RE: Site Plan Review application – Blue Tarp reDevelopment, LLC d/b/a MGM
Springfield (“MGM Springfield”)

Subject: Notice of Project Change
MGM Springfield, EEA #15033
Notice of Project Change

Reference: Review Comments on the Notice of Project Change for the Proposed MGM Springfield Development, EEA # 15033.

Figure 1

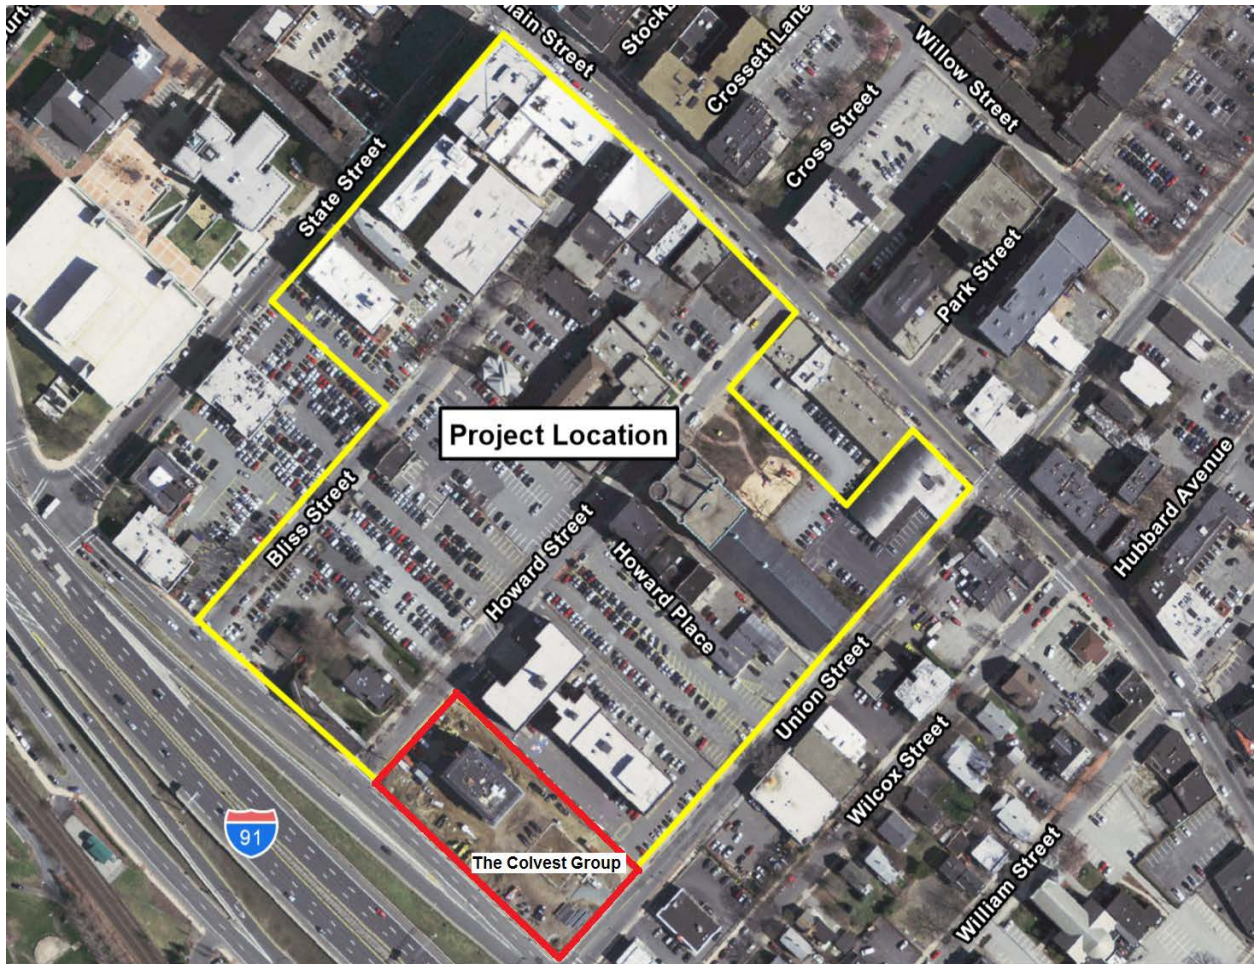
Colvest/Columbus Spfld, LLC’s property, located at 1259 East Columbus at the corner of East Columbus Avenue and Union Street, with through access to Howard Street, is directly southwest of the proposed MGM development (see Figure 1). The site features Class A office and retail space with access to Main Street via Union Street and Howard Street, access to Route 91 NB via the Union Street/East Columbus Avenue intersection, and access to Route 91 SB via Union Street and West Columbus Avenue.

The major concern of Colvest/Columbus Splfd, LLC remains to be the size and massing of the proposed parking garage. Although the proponent states, "The parking garage has been reduced by one level to a seven-story parking garage" on page 3 of the Narrative, in reality the size and massing of the garage has not changed. The proponent simply removed the basement level of the garage, which provides no mitigation or beneficial impact for anyone except the proponent who benefits from the cost savings of no longer having to excavate for the basement level. Furthermore, the Initial Site Plan Submission dated October 19, 2015 on the Springfield Redevelopment Authority website creates confusion as it shows eight levels of parking in the garage (see Figure 2). The basement level is no longer included but all 3,375 spaces mentioned in the Notice of Project Change are accounted for over eight levels of parking – not "seven stories" as claimed in the narrative.

Figure 2

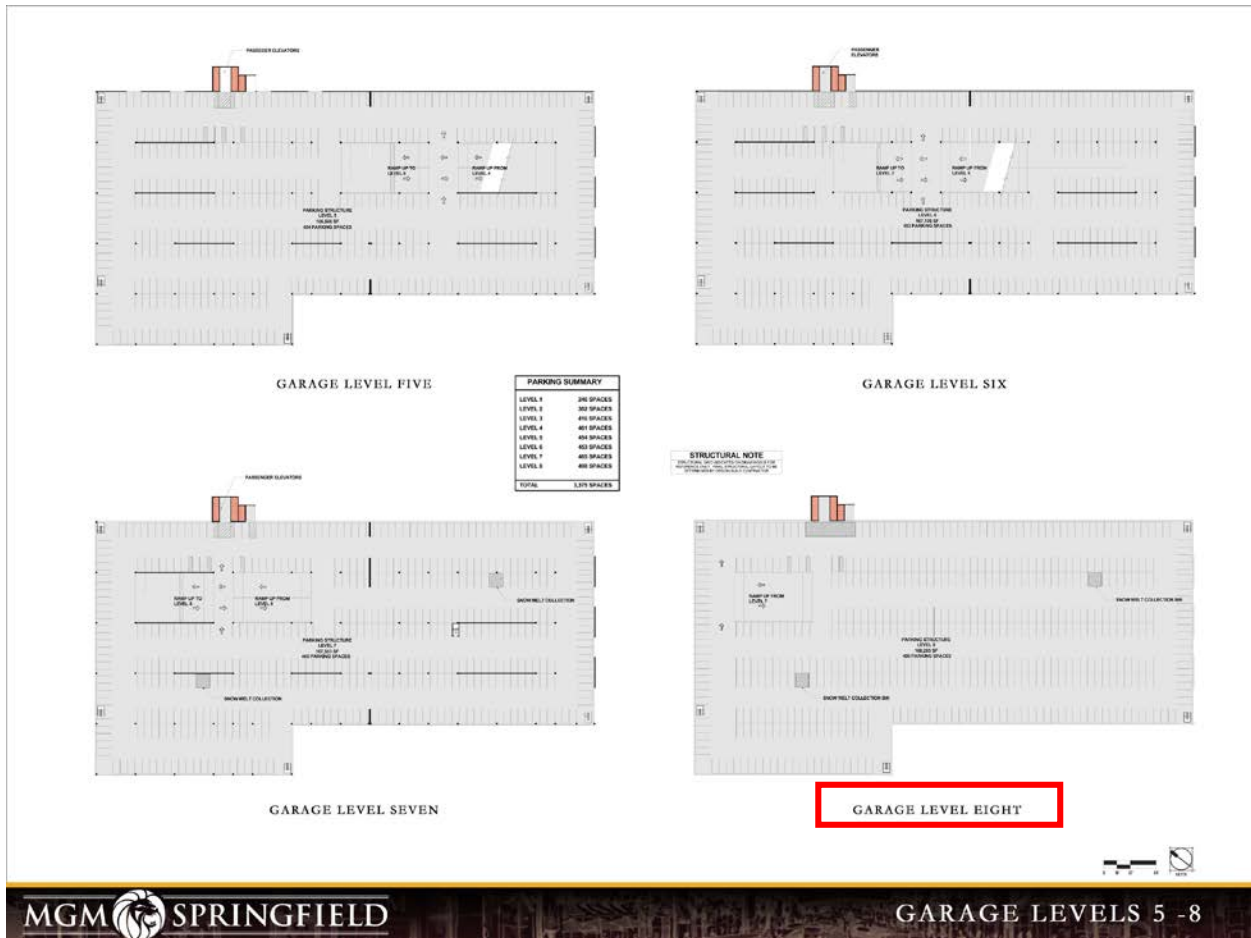
The shift in truck loading/unloading to the first floor of the garage caused the relocation of the large van parking that was previously shown on the first floor to either side of the central plant. The new parking location between Bliss Street and Howard Street is directly to the west of the Colvest/Columbus Spfld, LLC property. This surge in van traffic in combination with the escalation of vehicular traffic exiting the garage to Union Street will effectively increase traffic on both sides of the Colvest property. Yet again, Blue Tarp Redevelopment is not mitigating the impacts on the abutter but is, in fact, redistributing and increasing these impacts on both sides of the property. We recommend that instead of partially closing Howard Street as proposed, it should be closed in its entirety between the parking structure and East Columbus Avenue. Doing so would alleviate the detrimental impacts to the Colvest property as described above.

14. The updated Site Plan shows the Casino Generators remain between Bliss Street and Howard Street, adjacent to Colvest/Columbus Spfld, LLC. Generators of this type require frequent testing and if they are to be located that close to a sensitive receptor such as an office building, there needs to be substantial sound mitigation so that the generator testing does not disrupt the use of the office building by its tenants.
